#### ADDENDUM #1

Project: Lyman B. Goff Middle School Window Replacement Architect: Wessling Architects, 350 Granite Street, Suite 1103, Braintree, MA 02184 Architect Project Number: 22081 Date of Addendum: December 29, 2022

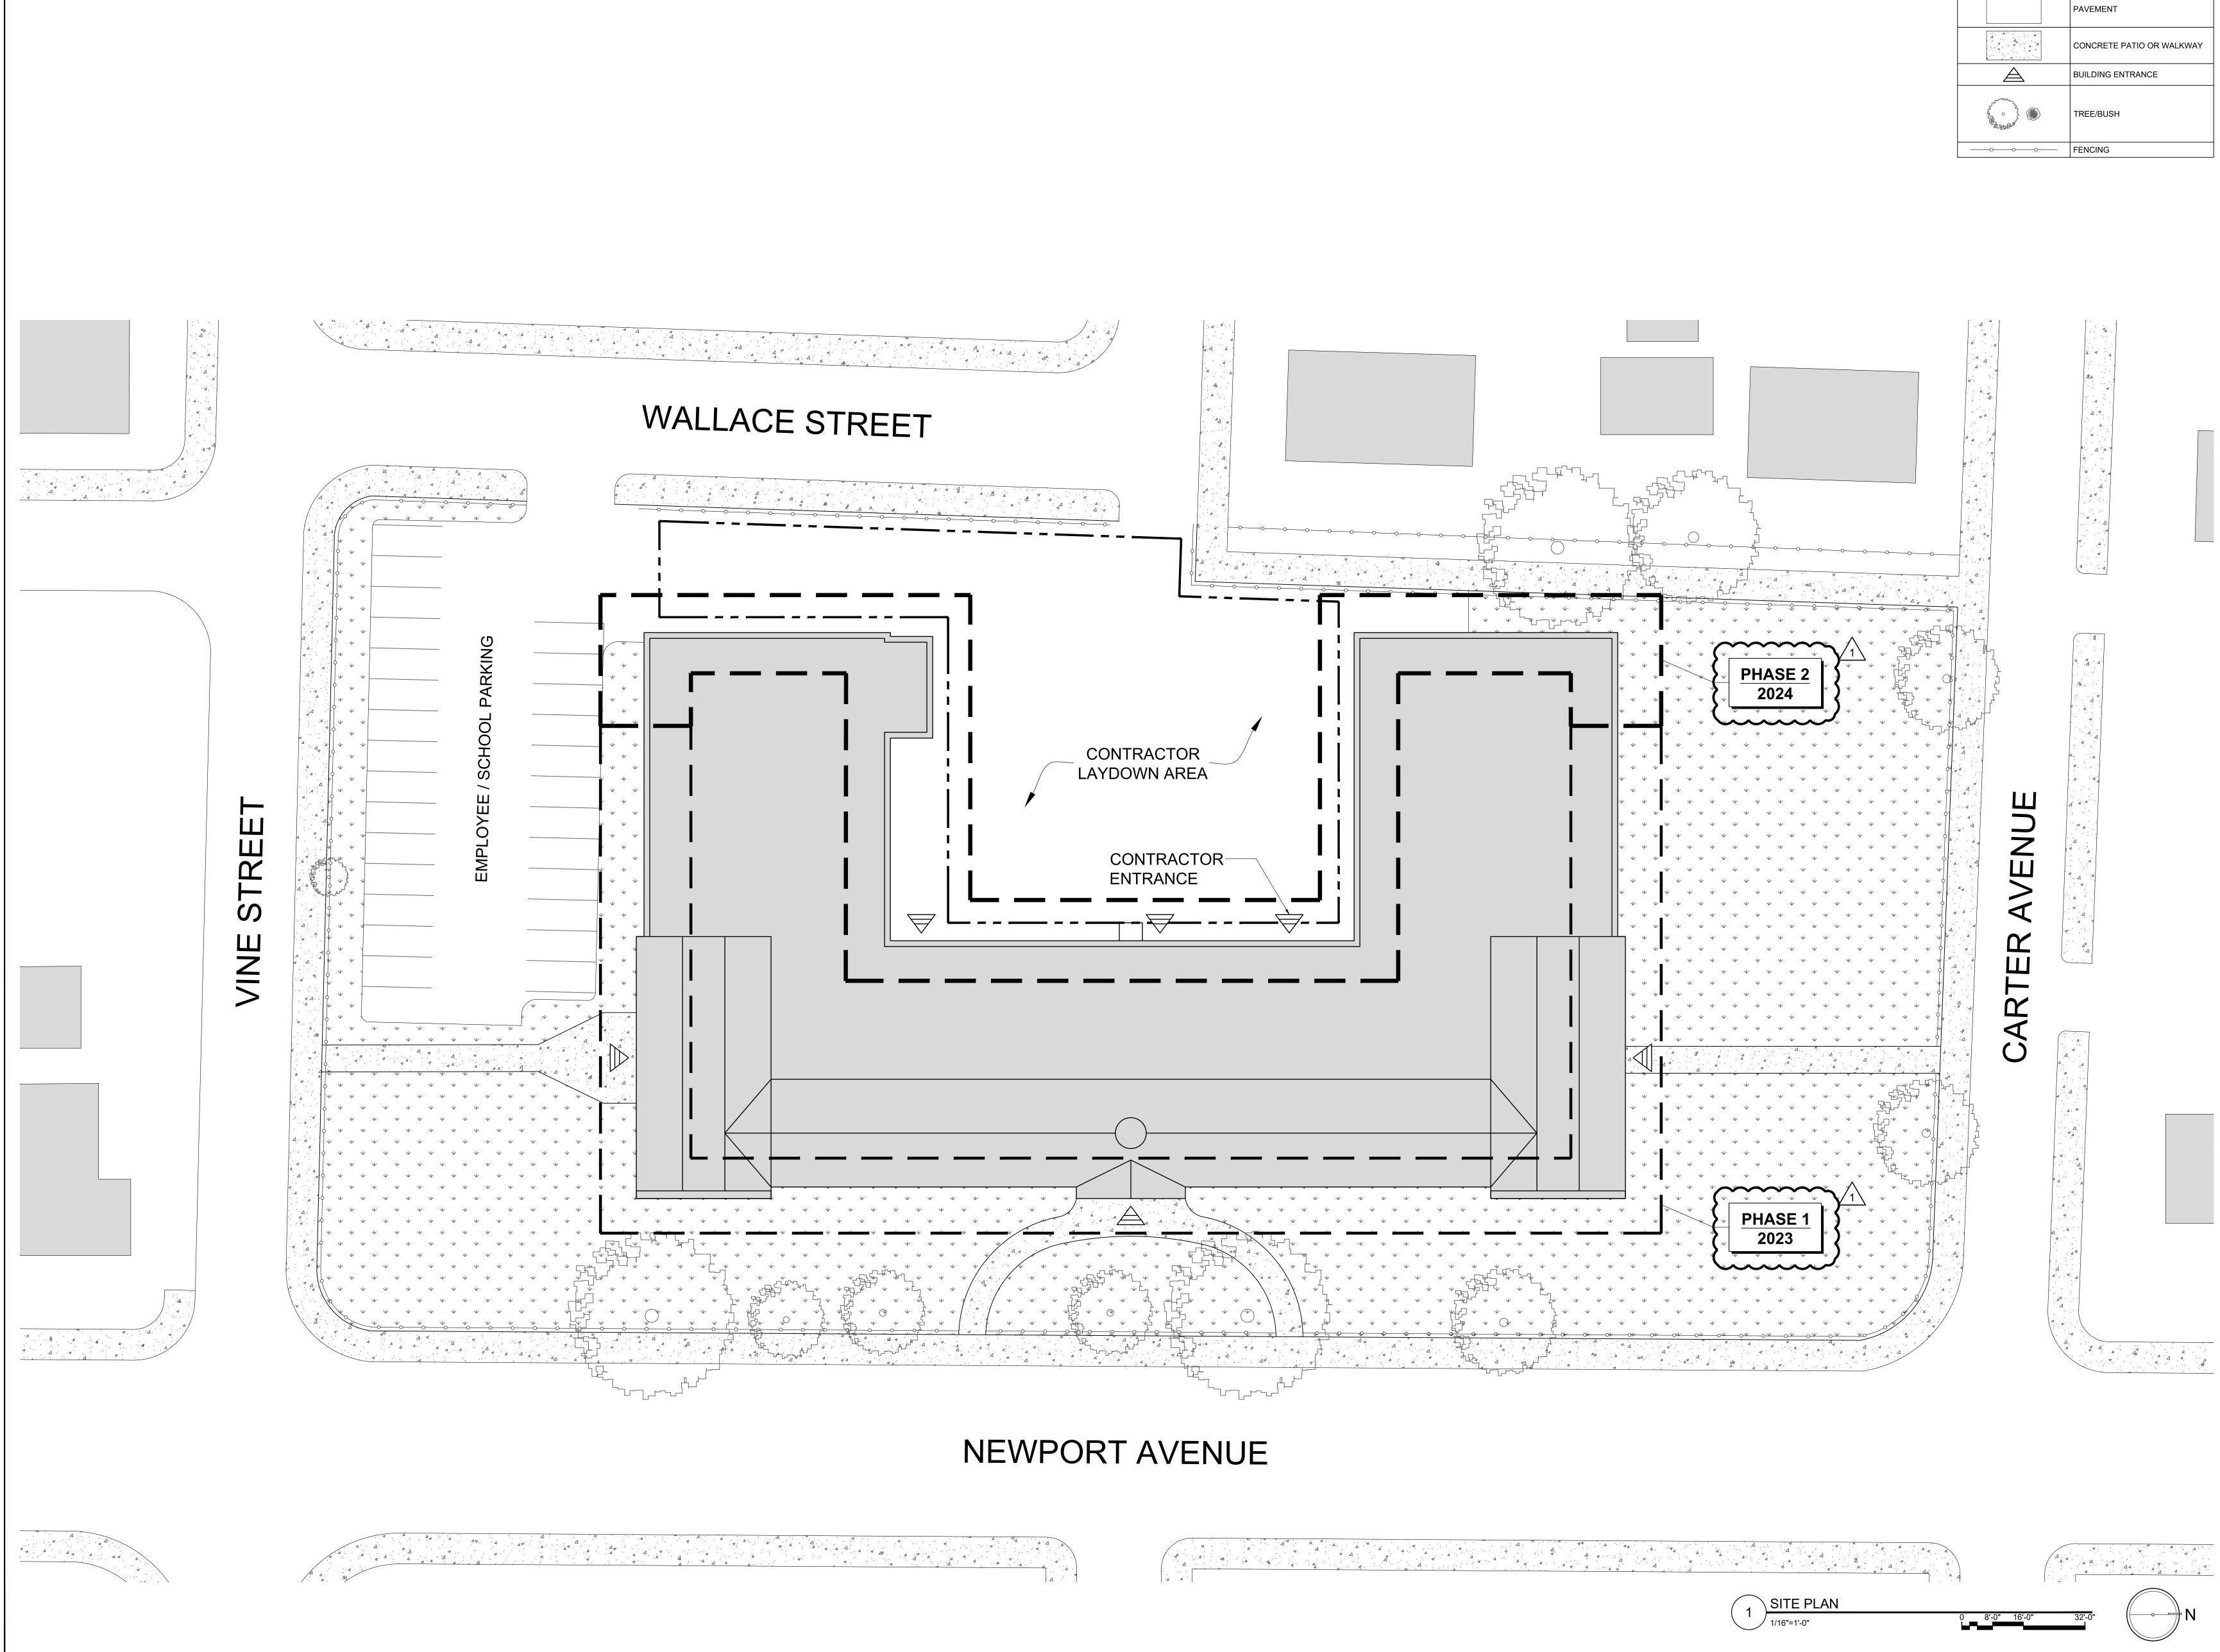
MODIFIED: Unit Prices added to Summary of Work.

ADD: The window and door caulking has been tested and found to contain 3% asbestos. A licensed and certified asbestos contractor is to remove and dispose of all asbestos containing materials in full accordance with applicable local, state and federal laws, as well as OSHA requirements. An asbestos abatement plan with more specific information and quantities will be issued in Addendum #2.
